**TOWN OF GLASTONBURY  
REQUEST FOR PROPOSAL  
RPGL-2018-21  
RENEWABLE ENERGY PROJECTS –  
POWER PURCHASE AGREEMENT  
ADDENDUM NO. 2  
04/30/18**

**Questions and Answers**

# Glastonbury High School

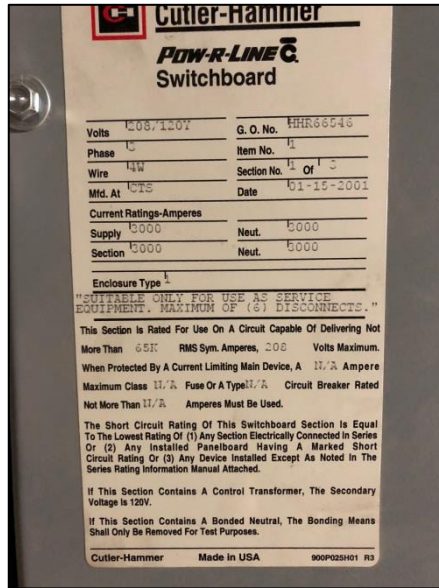
8. **Question:** Can you please provide photos of all electrical rooms?

**Answer:** *See Attachment B.*

TOWN OF GLASTONBURY  
EMERGENCY POWER SYSTEM  
MDF ROOM WEST SIDE  
GLASTONBURY HIGH SCHOOL

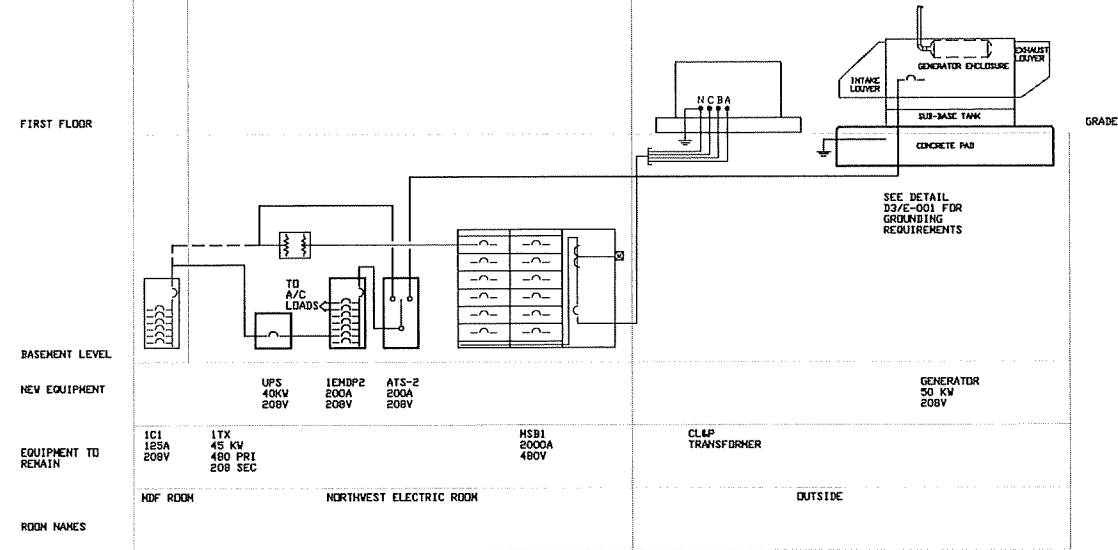
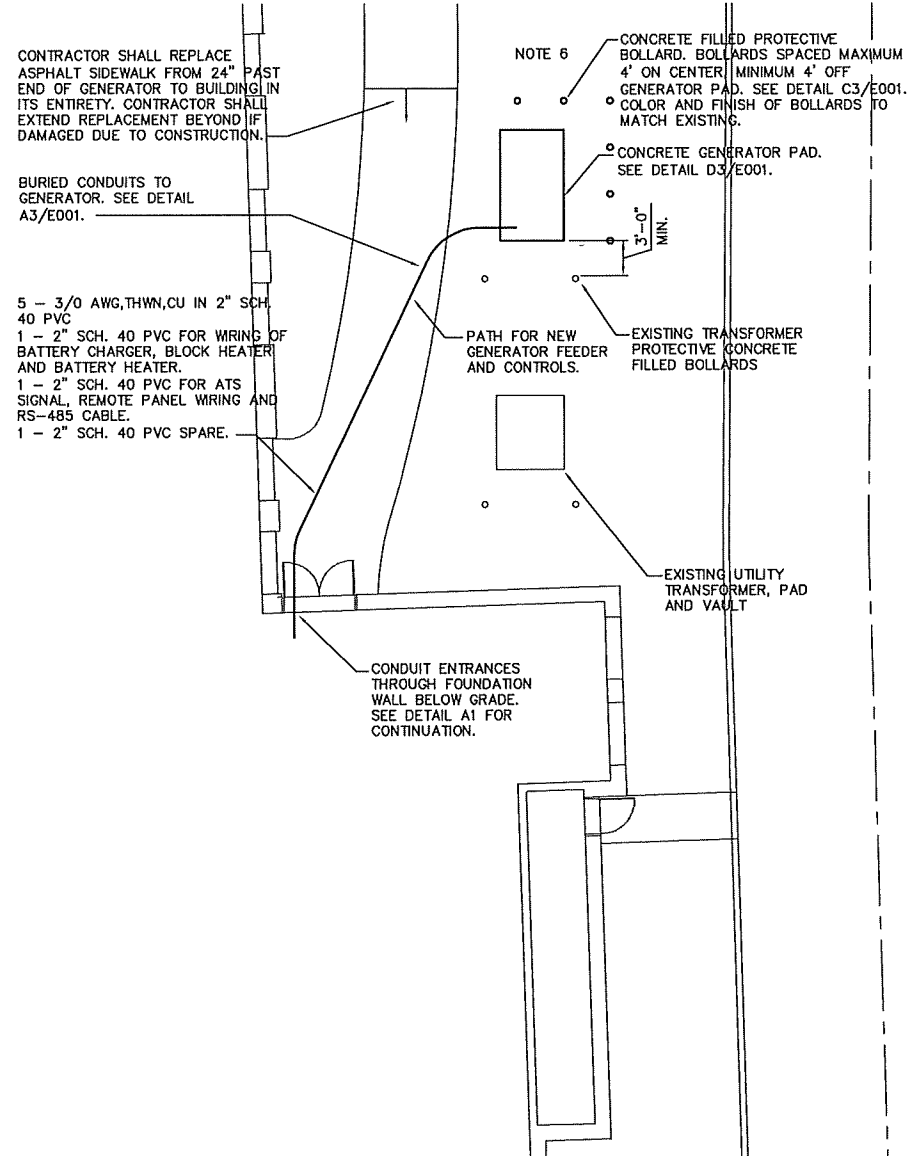
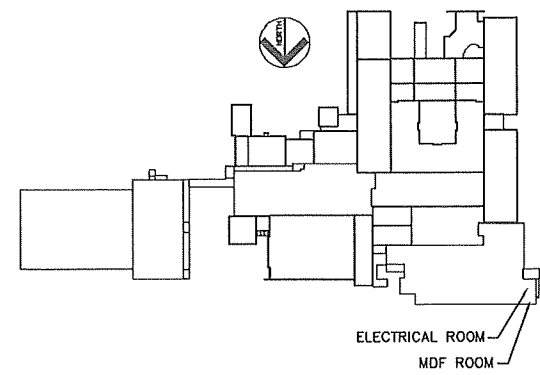
10. **Question:** For the High School, can you please let us know where on site the electrical room is located?

**Answer:** *There are two; See Attachment C.*
